**STATEMENT OF COOPERATION BETWEEN THE STATE OF KANSAS,
AN AGREEMENT STATE, MINE SAFETY AND HEALTH ADMINISTRATION
AND THE NUCLEAR REGULATORY COMMISSION**

The purpose of the Statement is to establish the basis for the preparation of a joint environmental assessment and on-site safety assessment for Rickano Corporation's low-level waste operation at Lyons, Kansas, as provided for under section 274 of the Atomic Energy Act, as amended. In addition to the statutory provision of the Act, each agreement entered into with a State for State assumption of regulatory authority over agreement materials contains an article pledging the use of best efforts on the part of the Commission and the State to achieve coordinated and compatible programs. The low-level waste operation proposed for the Lyons, Kansas salt mine is expected to have significant impact upon the human environment.

Following this the Kansas Department of Health and Environment directed a number of questions to us, asking us to expand on our application's procedures and policies. We are completing the final draft of our response to them this week.

OPERATIONS BUILDING

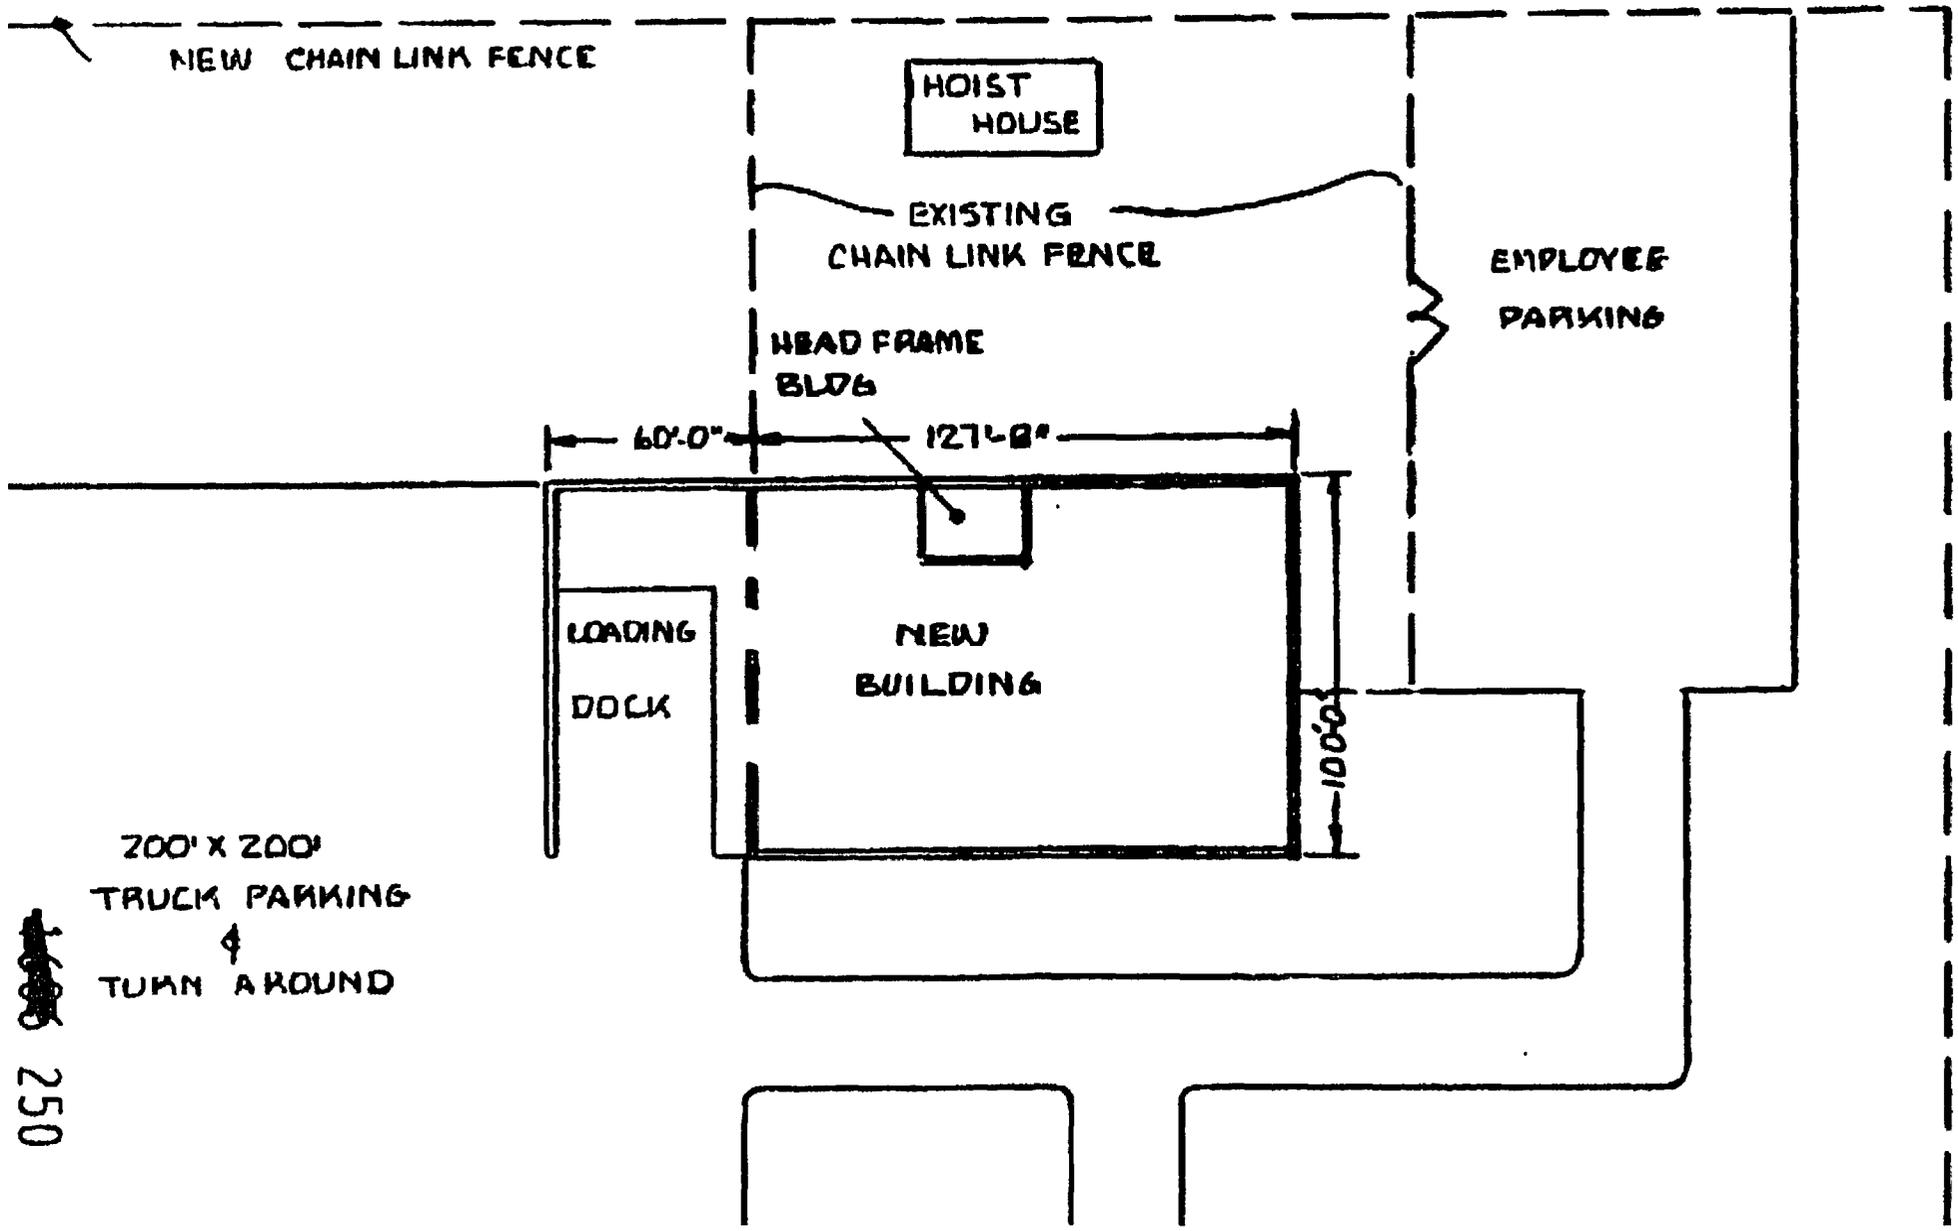
Question 1 (a,b,c,d,e,f,g,i,li)

A description of the operations building, parking lots, and associated facilities and equipment along with a detailed analysis to bring the shaft and hoisting equipment up to Mine Safety and Health Administration (M.S.H.A.) standards is attached.

A cost of approximately \$250,000 plus a time of up to 150 days is required for the operations building and parking area and associated equipment.

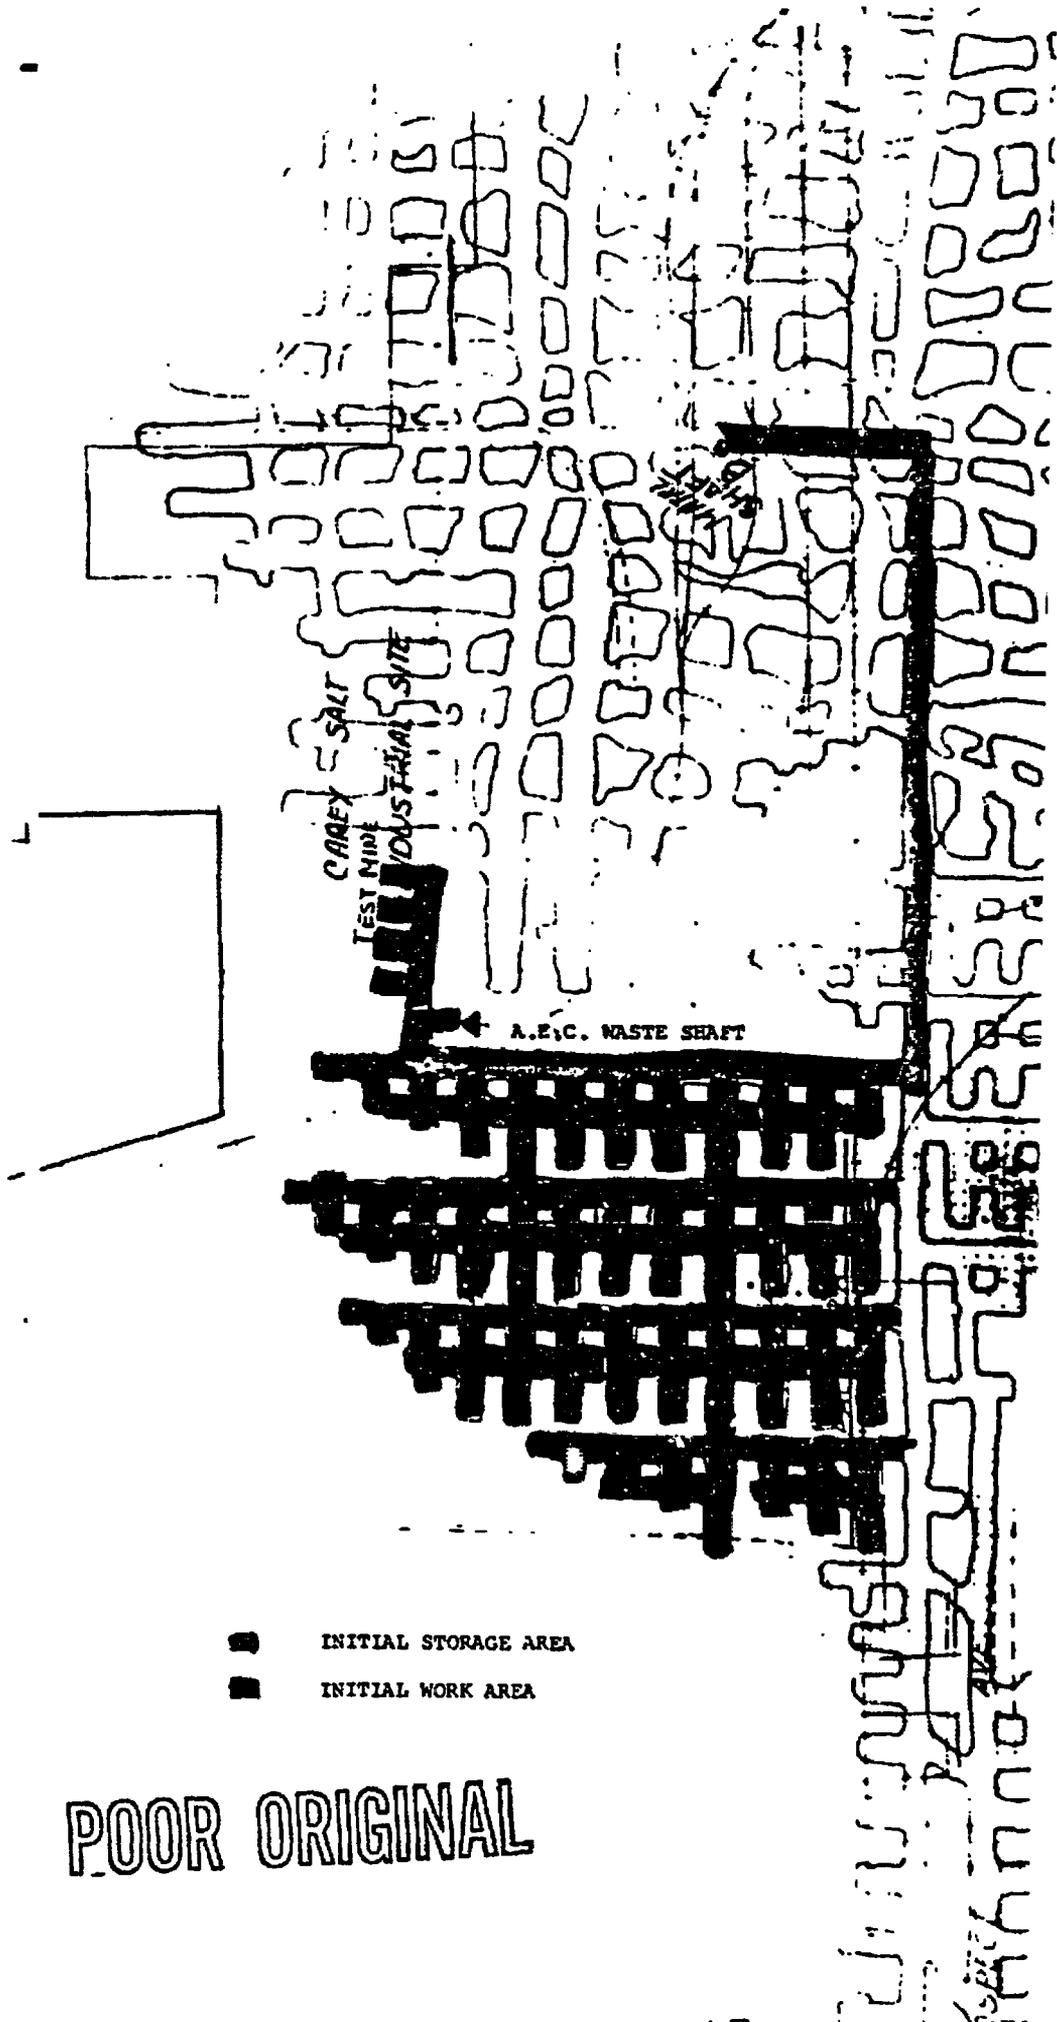
Question 15

The above ground storage and working areas are noted in sketches submitted with Question 1.

As can be seen on this drawing, the storage and working areas wherein Radioactive Material are actually handled consist primarily of the unloading dock and the north and central sections of the operations building.

These above ground areas are all under roof, within metal walls with concrete floors. The unloading area is black top or asphalt except for the dock which is concrete.

OPERATIONS BUILDING

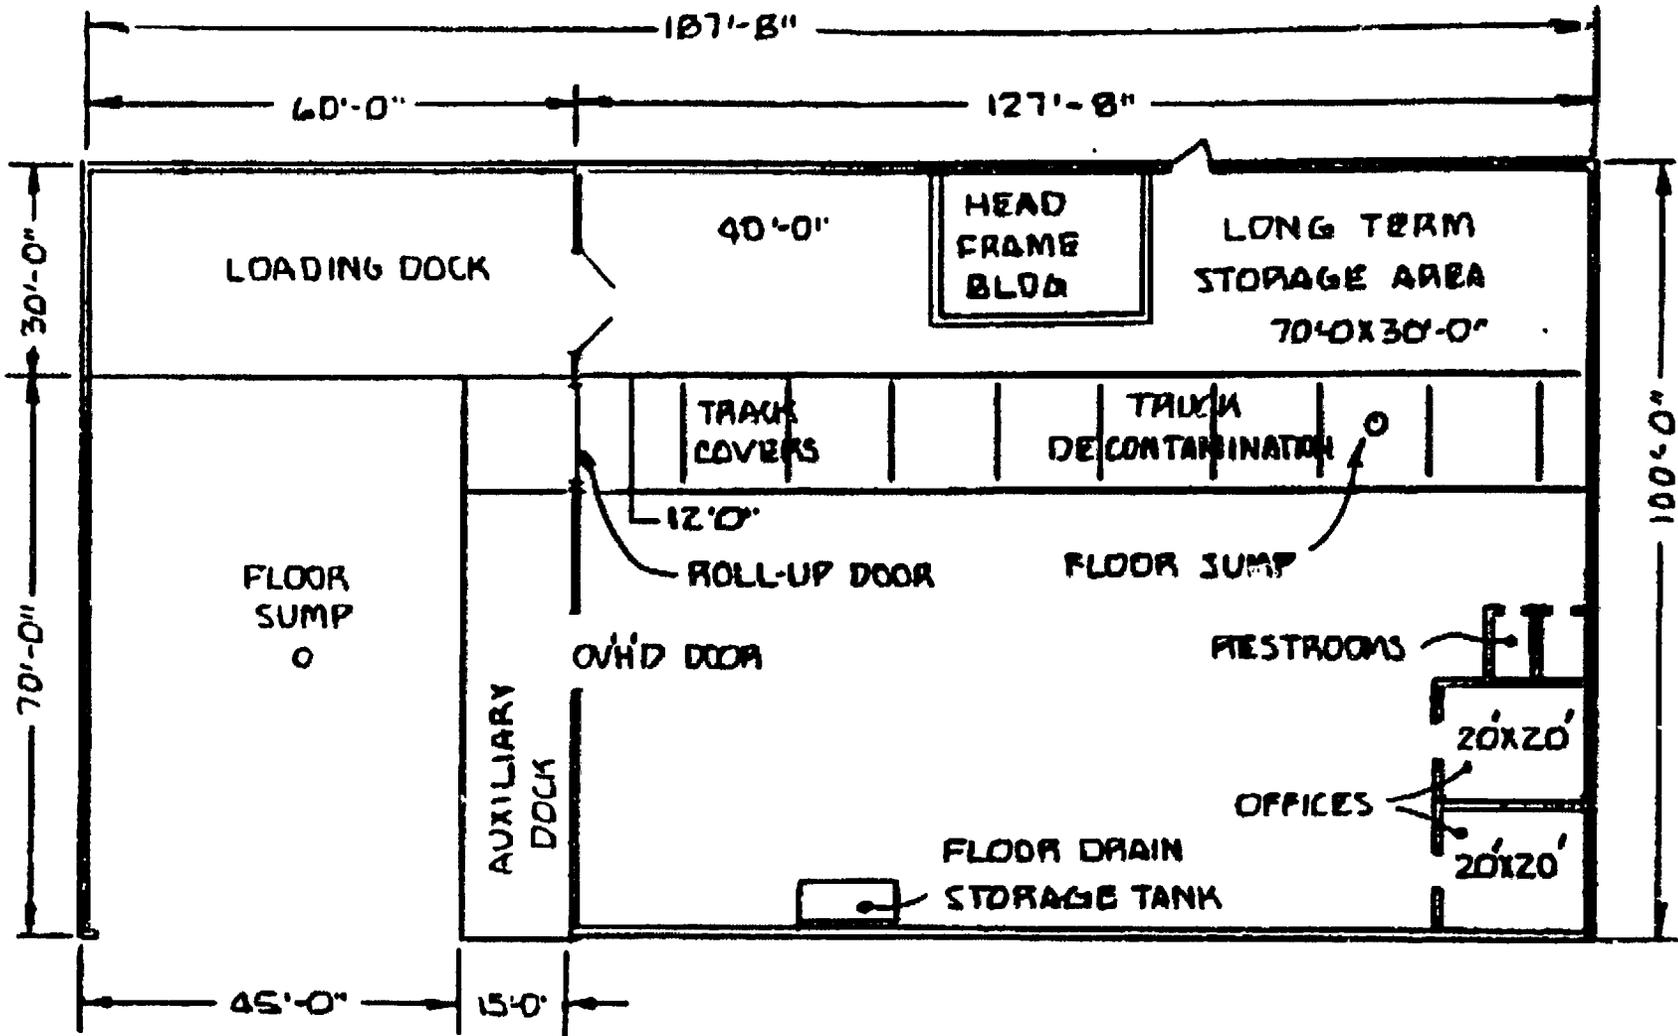
Question 36

Regarding the above ground long term storage area wherein we previously asked for a 6 month storage permit for radioactive waste materials, we would like to submit the following:

1. We would like to reduce the time to 90 days and redesignate this as temporary rather than long term storage area. We feel this should be adequate time to trans-ship radioactive waste containers not destined for mine storage.
2. We have designated an area in the Operations Building (see attached sketch) as the temporary 90 day storage area. This area will be approximately 500 sq. ft. in area.
3. In the unlikely event of dose rate problems, supplemental shielding will be provided in the form of concrete blocks or metal sheets.

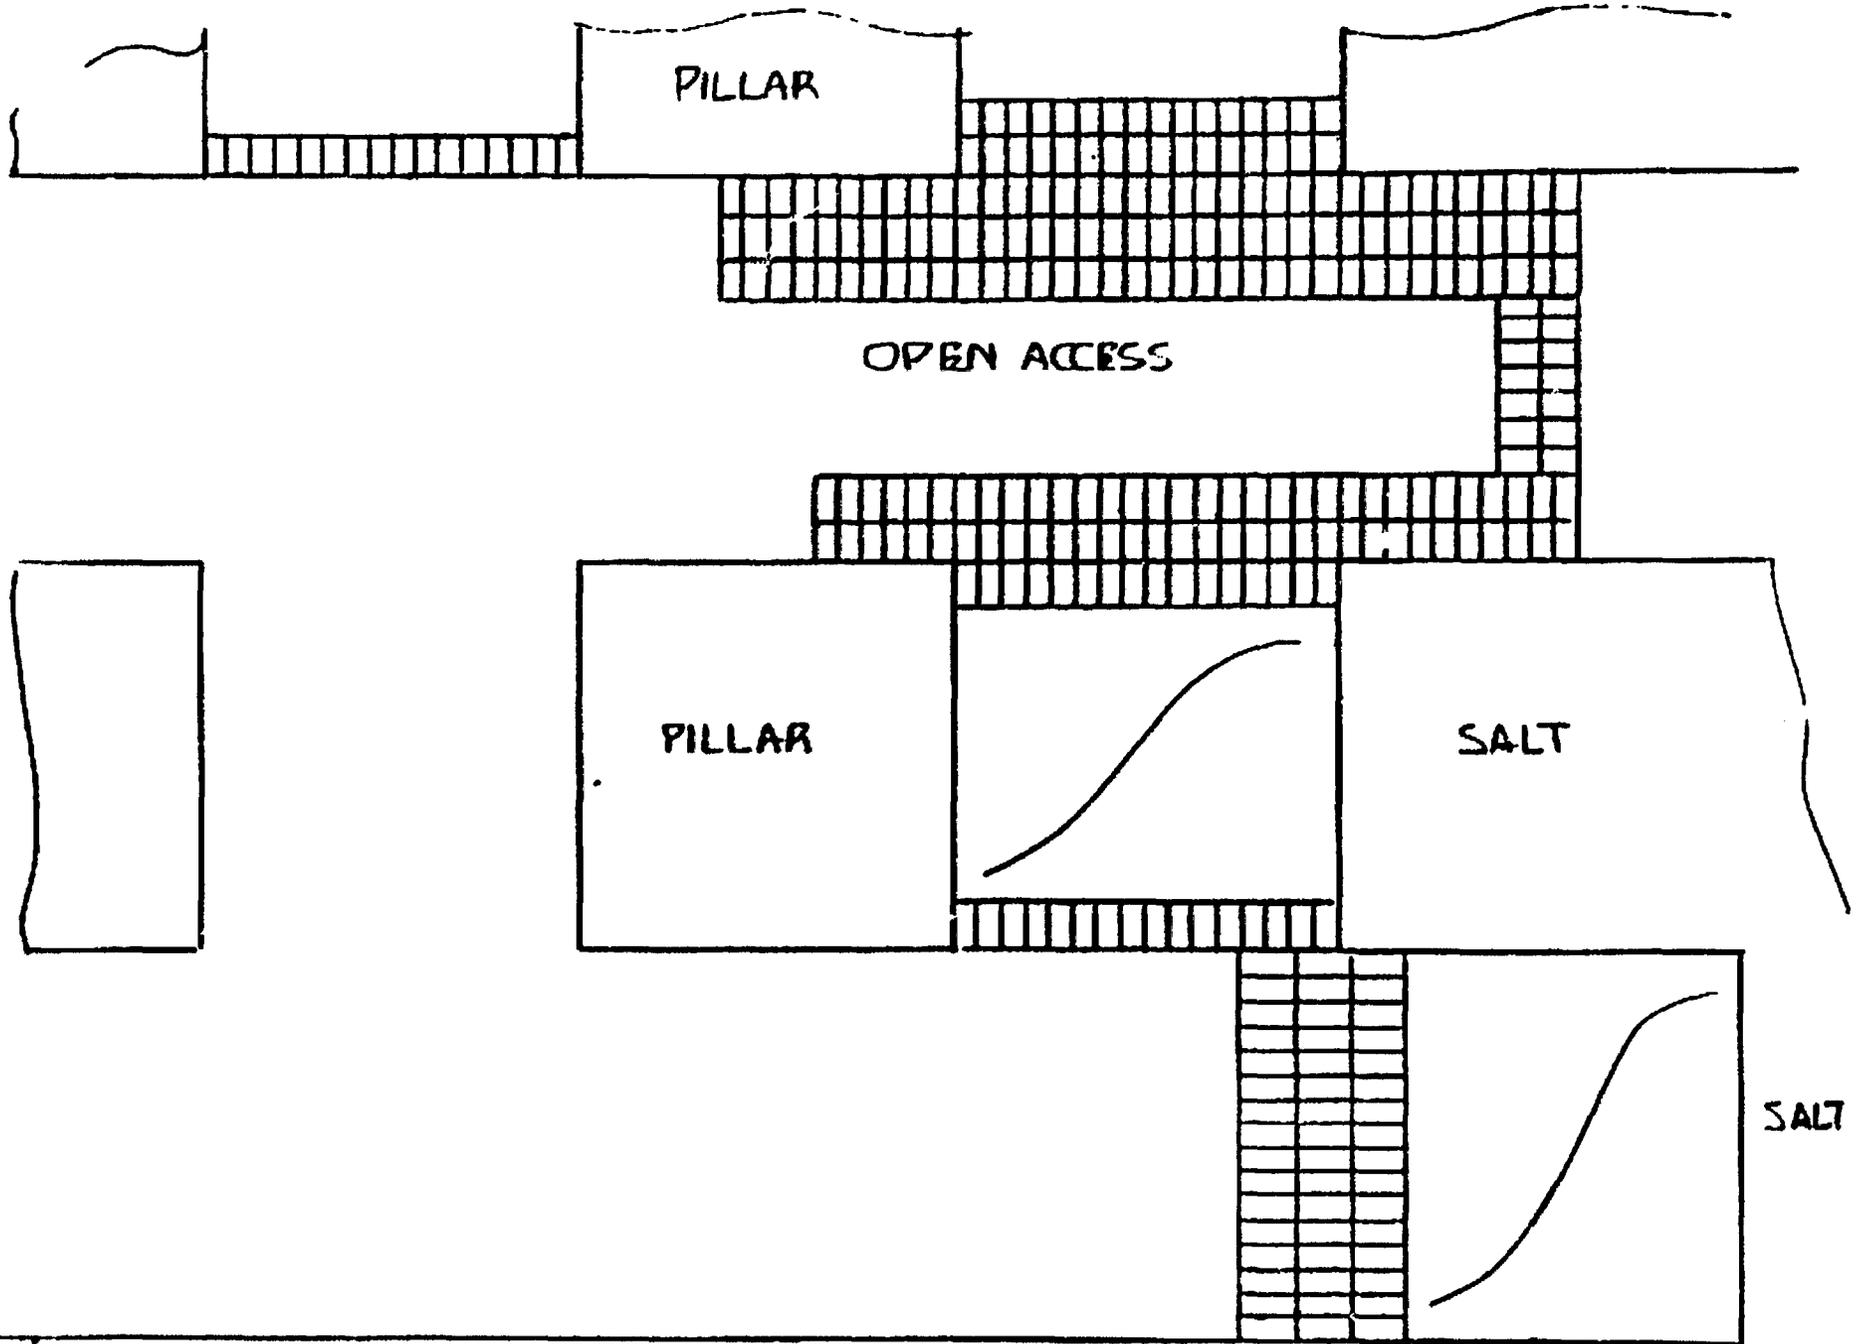
Question 39

Concerning the incorporation of an access to the filled storage cells, we have re-evaluated our procedures and have decided to treat the whole mine as one large storage cell. We will stack the containers in such a manner that, for the most part, they will be available for visual inspection. This will be accomplished by providing access passageways between the containers as required for inspection of monitoring and data collection. (See attached sketch)
